February 7, 2022

Chairman and Members of the Historic Preservation Board
c/o Debbie Tackett, Chief of Historic Preservation
City of Miami Beach
1700 Convention Center Drive
Miami Beach, Florida 33139

Re: Objection to Application for Certificate of Appropriateness for the partial demolition, renovation and restoration of the existing building, including the reconstruction of original interior floor plates, modifications to the rear cabana building and site improvements for the property located at 1685 Collins Avenue, Miami Beach, Florida (Historic Preservation Board File No. 17-0176).

**PROPOSED
 SITE PLAN**

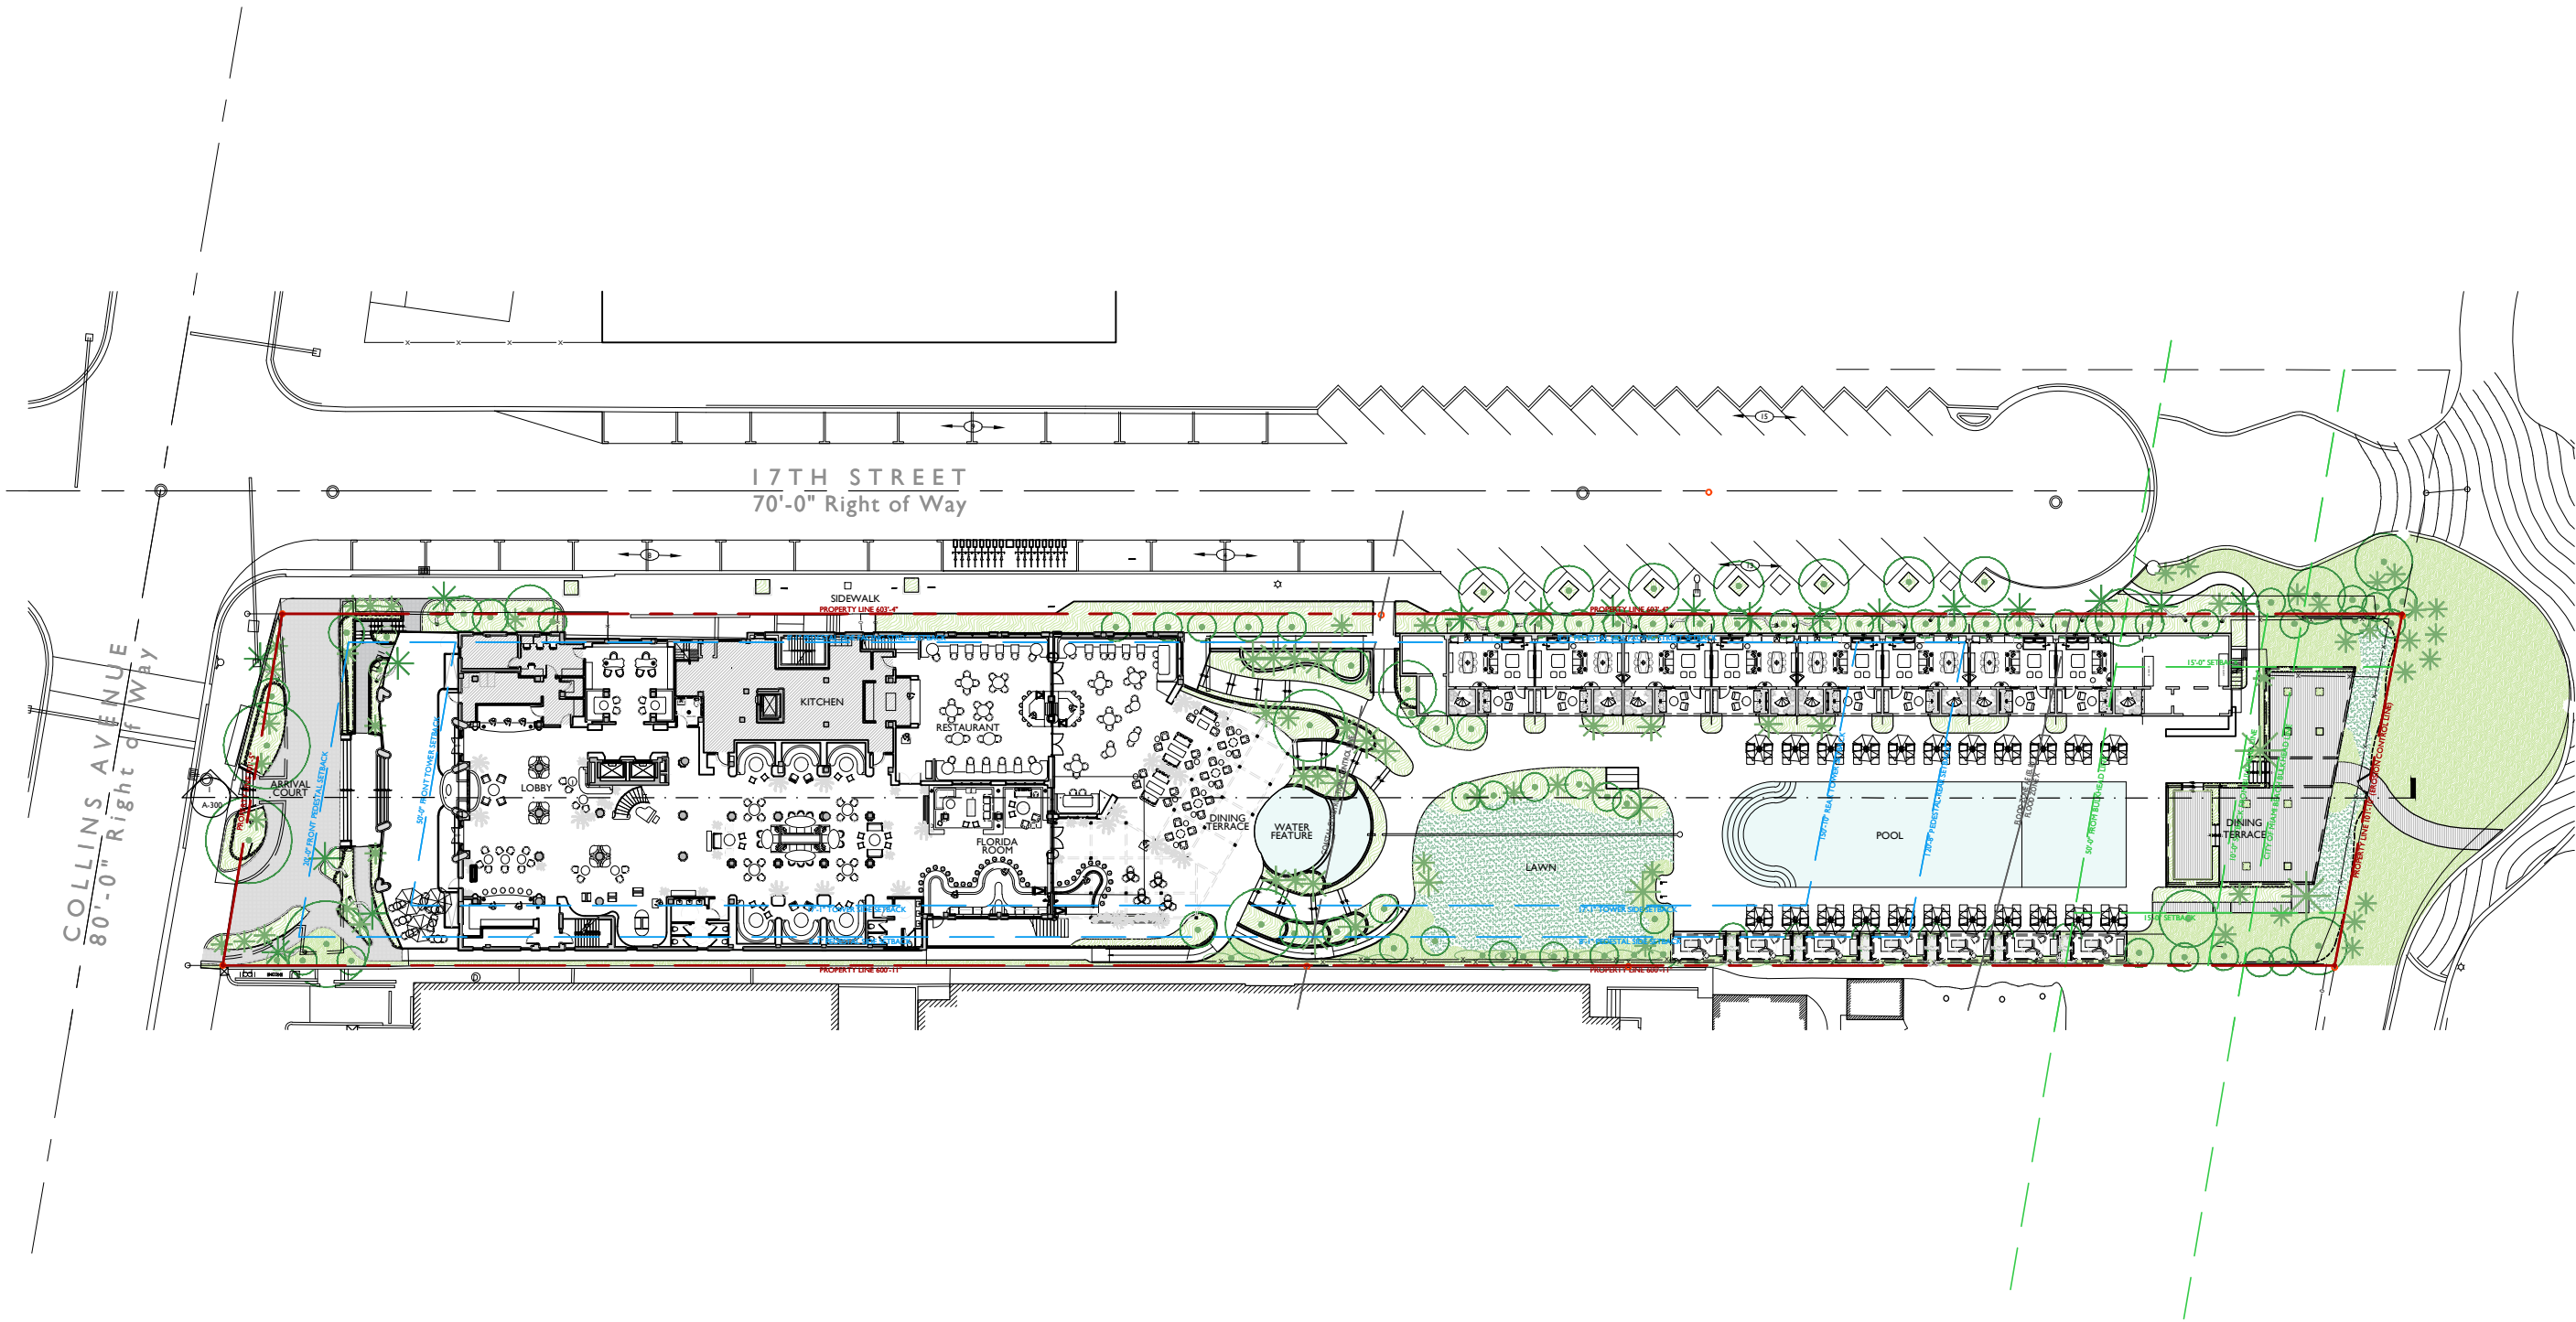
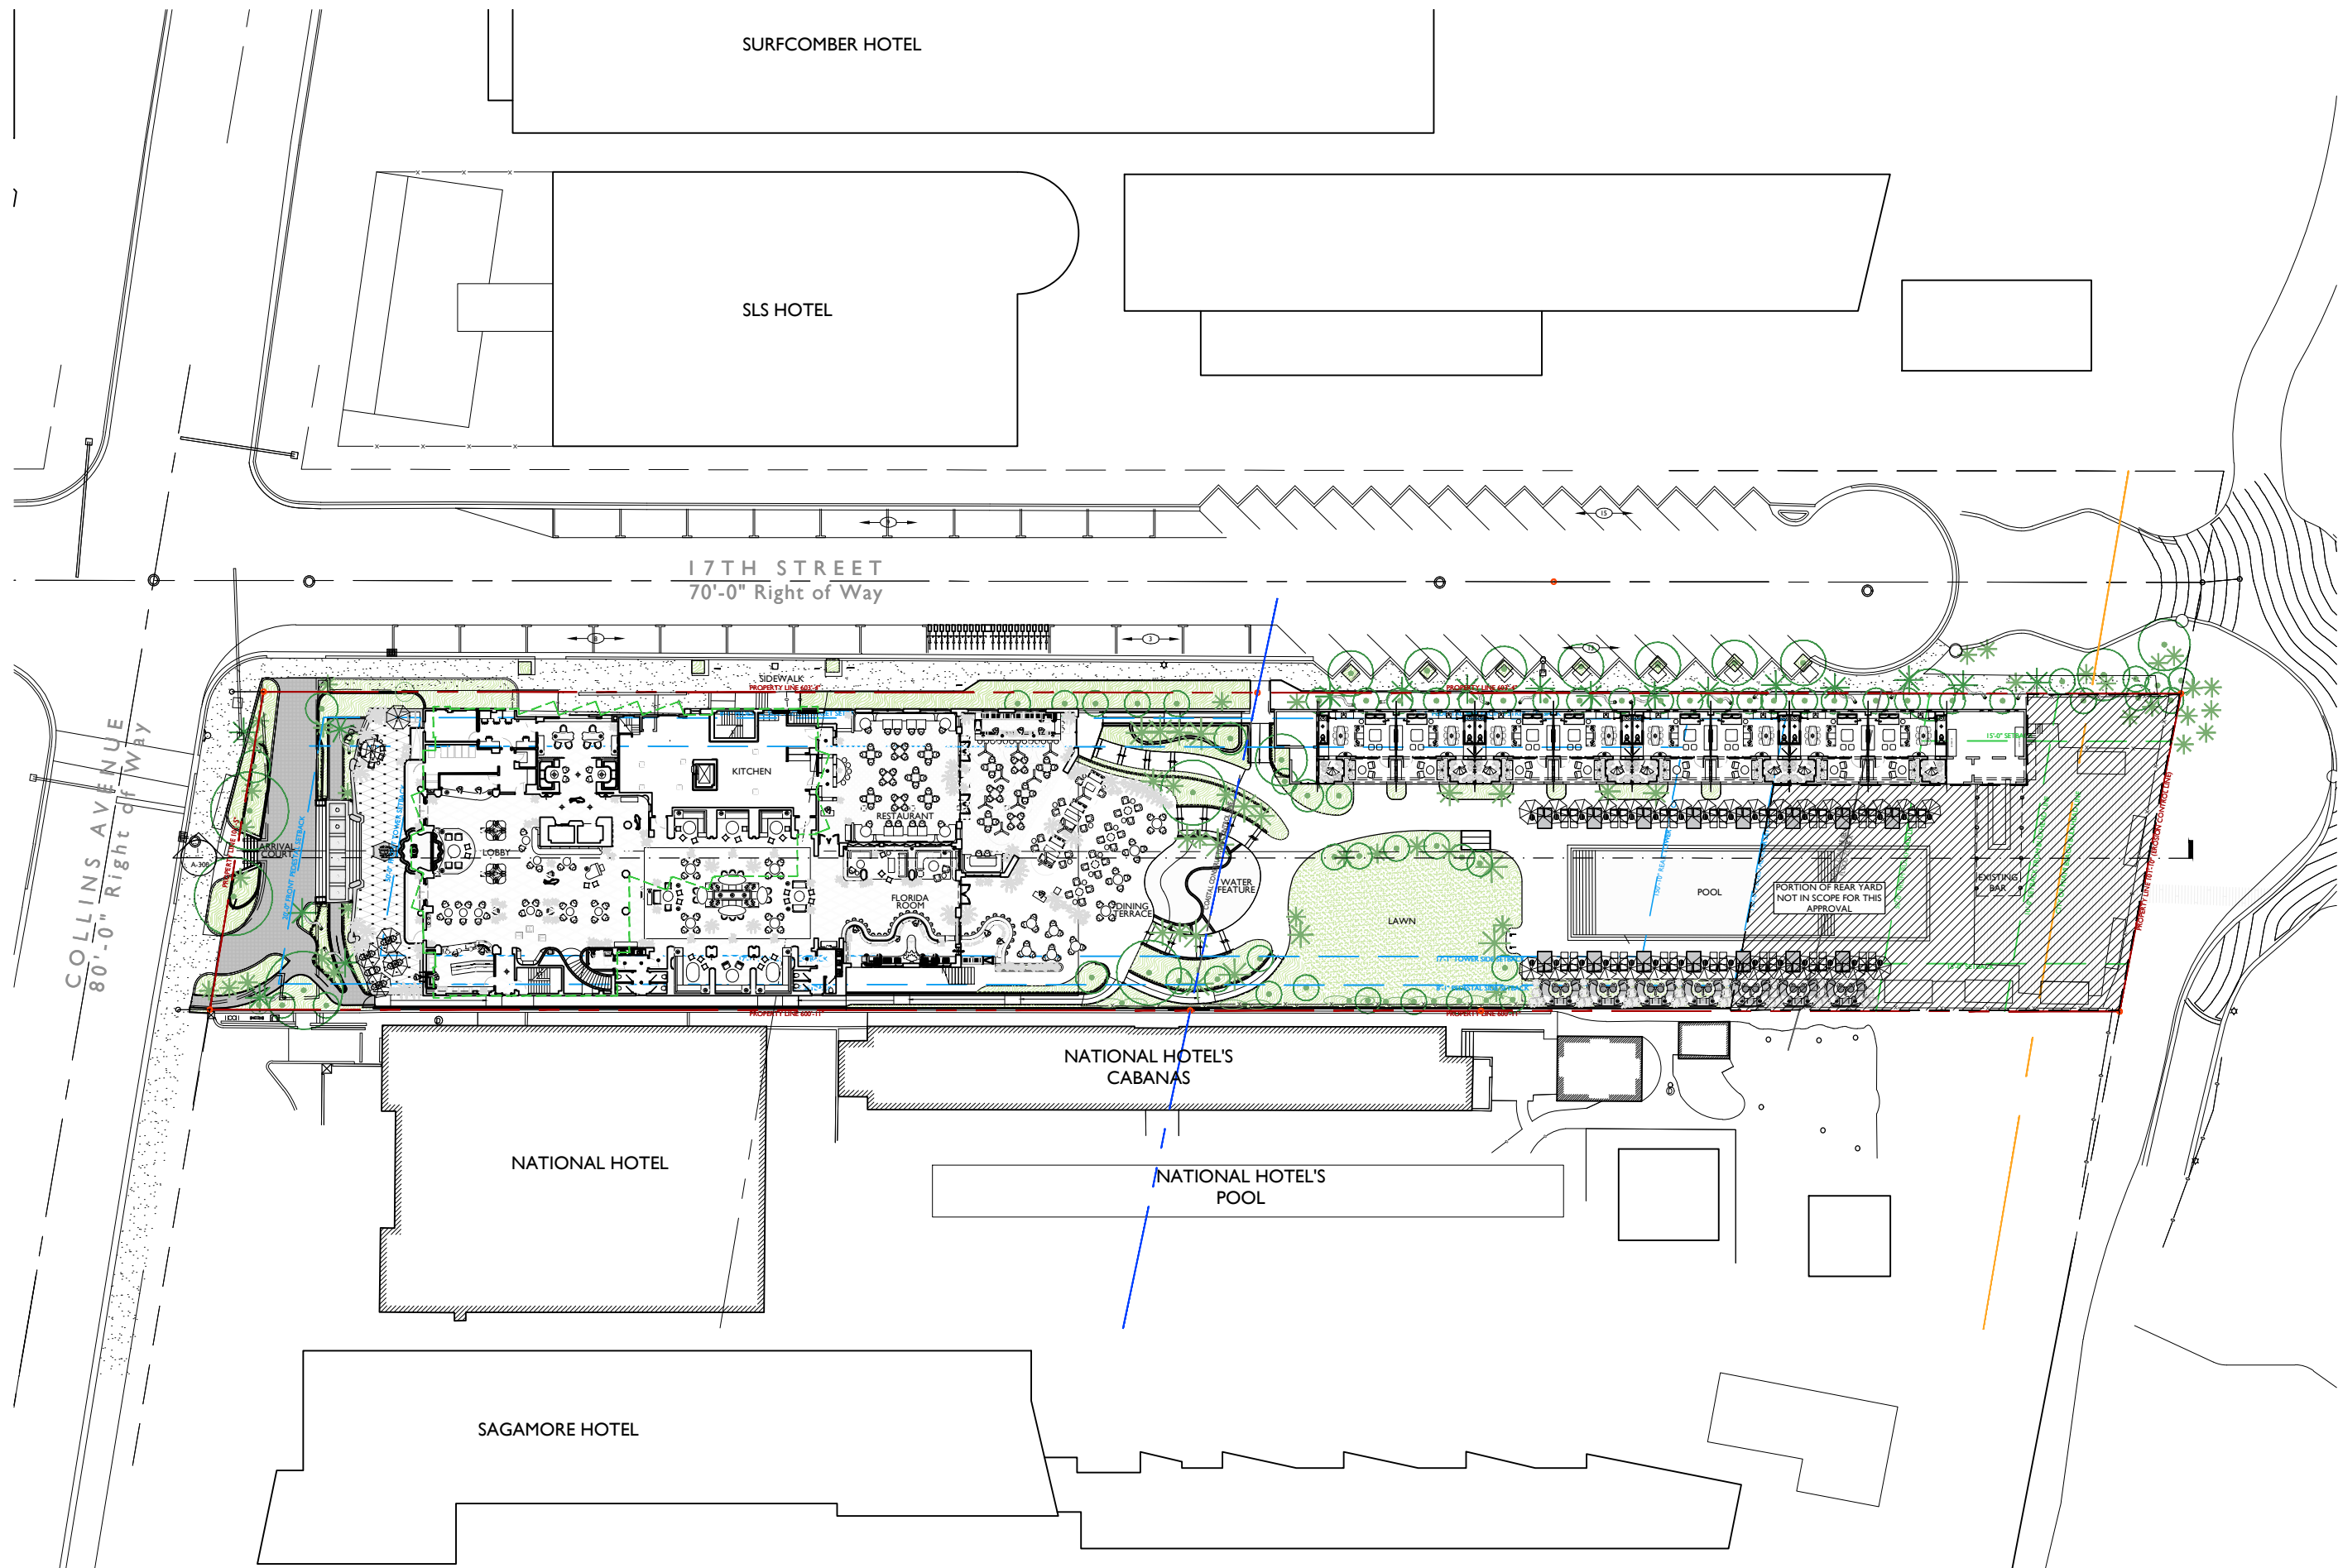
Further, to avoid scrutiny of the six zoning violations in the dune preservation overlay and the oceanfront bulkhead setback, open space and view corridors, the Applicant is trying to sever the rear half of the site from review by this Board by adding hash lines on a part of the latest Site Plan and providing the caveat “Portion of Rear Yard Not in Scope for this Approval.” Compare copies of the original and current Applicant Site Plans, A2.00 attached hereto.

Removing a section of the Site Plan from HPB review is contrary to the application requirements for a Certificate of Appropriateness which requires a “complete site plan” for review. Indeed, the removal of those portions of the site plan is contrary to the application requirement for a Certificate of Appropriateness to have a “Complete Site Plan” for review. Should the site plan be incomplete, the Application cannot be reviewed for compliance with the review criteria and the Applicant is not authorized by the Code to unilaterally remove those critical sections from the Site Plan on its whim. Indeed, Sheets A.1.02C and A 1.03B of the plans before the Board demonstrate that the Applicant intends to demolish structures and hardscape in the same area on which the Applicant drew its hash marks on the current Site Plan and in that same area that Applicant unilaterally contends to be in the “Portion of the Rear Yard Not in the Scope for this Approval.” See Site Plan A.2.00.

By purportedly removing portions of the Site Plan from review by this Board, it is removing sections of the plans that the Board is compelled by the Code to review and for the criteria which Board decisions must consider including, but not limited to, §118-56(2)a, b, c, d, f and h and consideration of the architectural drawings including, but not limited
